Docket Item # 6 & 7
BAR CASE # 2013-0090/0091

BAR Meeting
May 1, 2013

ISSUE: Permit to Demolish/Encapsulate and Alterations

LOCATION: 1 Prince Street

Figure 1. The East Elevation of the Strand Building from Waterfront Park showing the proposed balcony location and the existing balcony on the building at the north end of the row.

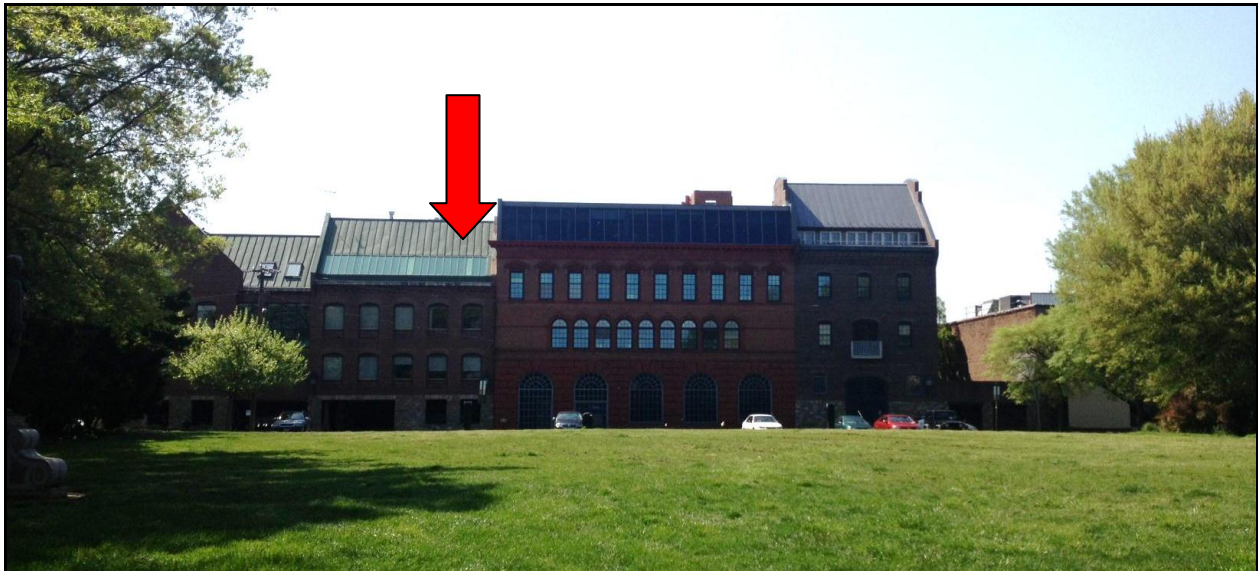
However, the specific location of the balcony – driven primarily by the interior layout – does not relate to the regular symmetrical bays of the fenestration on the brick building below, making it look like an afterthought.

Staff recommends approval of the new balcony, provided that the width of the balcony is adjusted very slightly to align with the brick piers and punched windows on the floors below, so that it looks like it was designed as an integral part of the original building.

1 Partial East Elevation
1/8" = 1'-0"

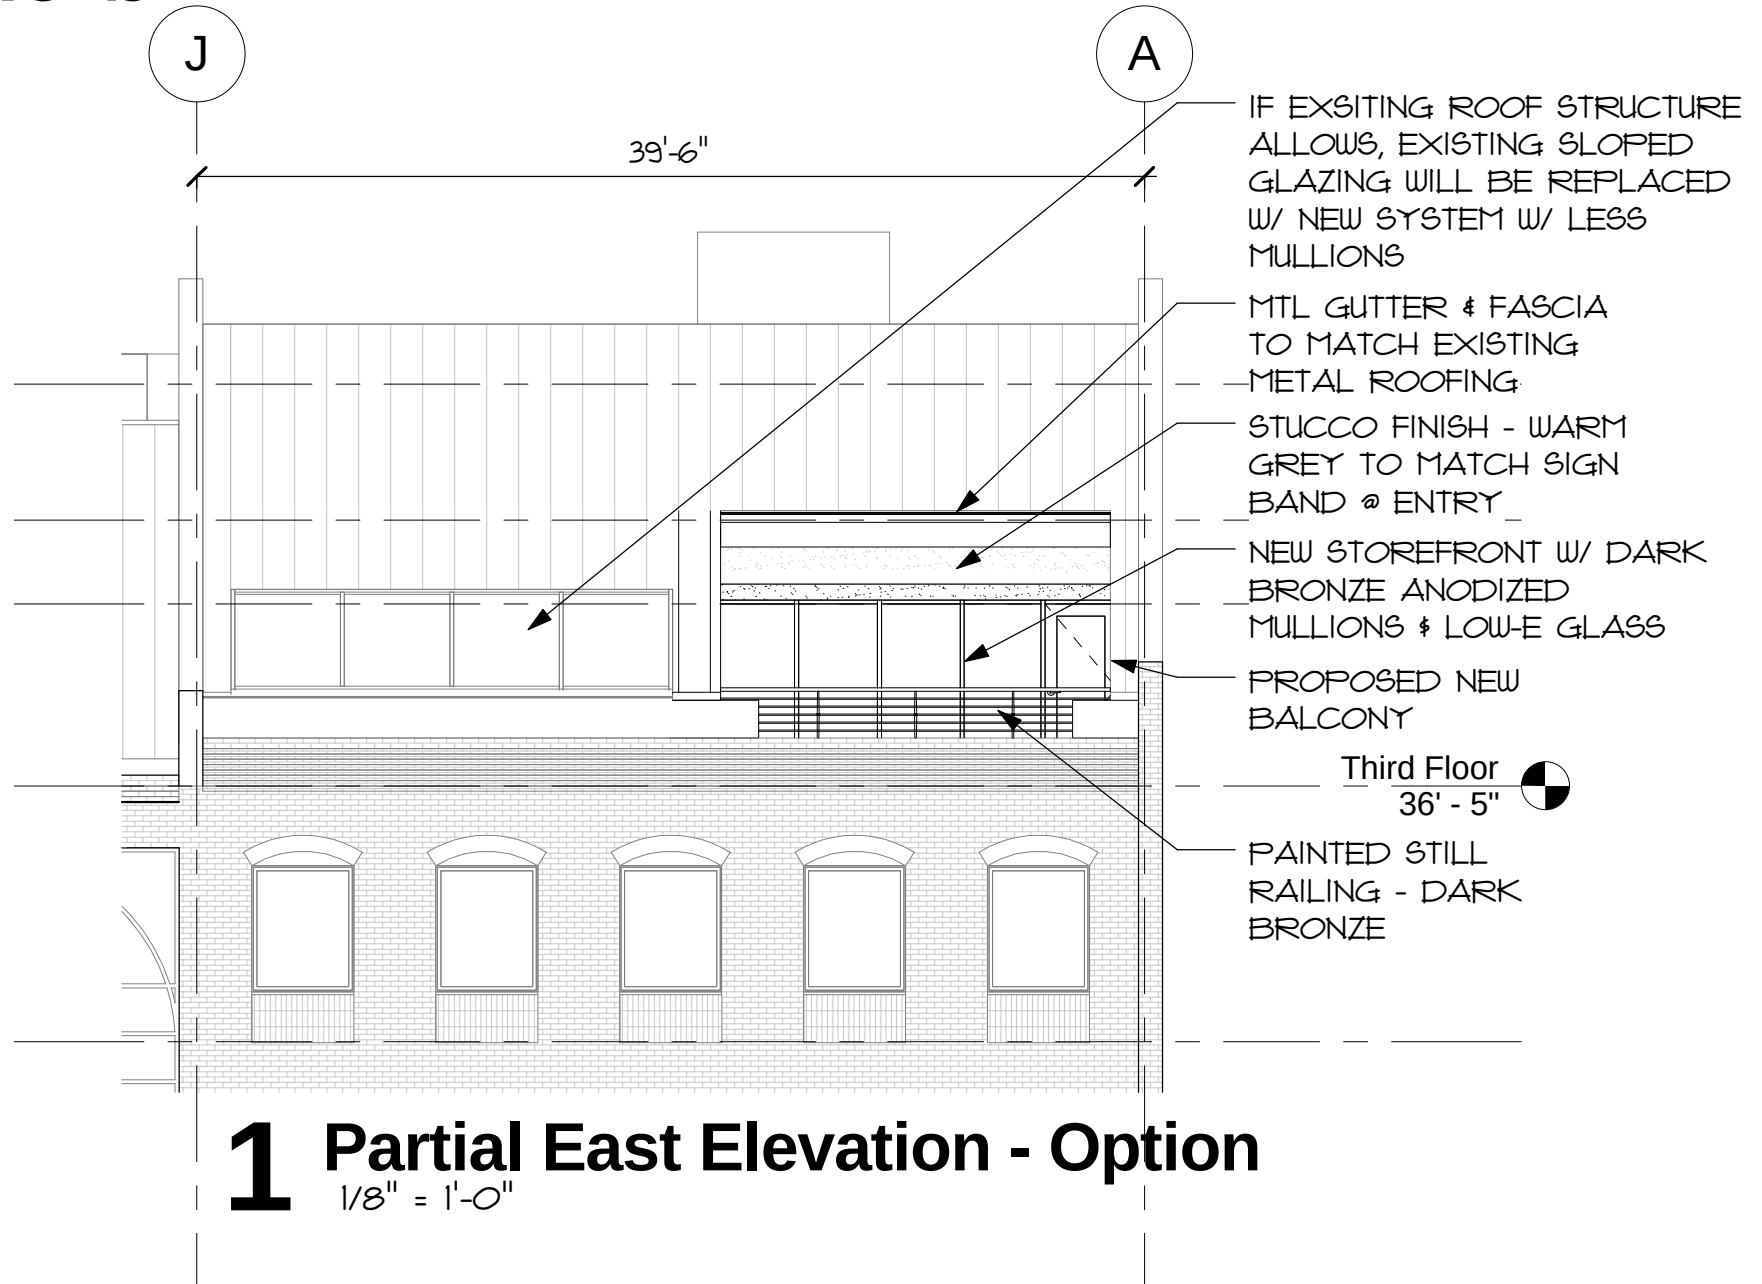
Staff recommends approval of the Permit to Demolish/Encapsulate and the Certificate of Appropriateness for alterations, with the condition that the balcony opening in the roof align with the brick piers and punched openings on the lower floors of the east facade.
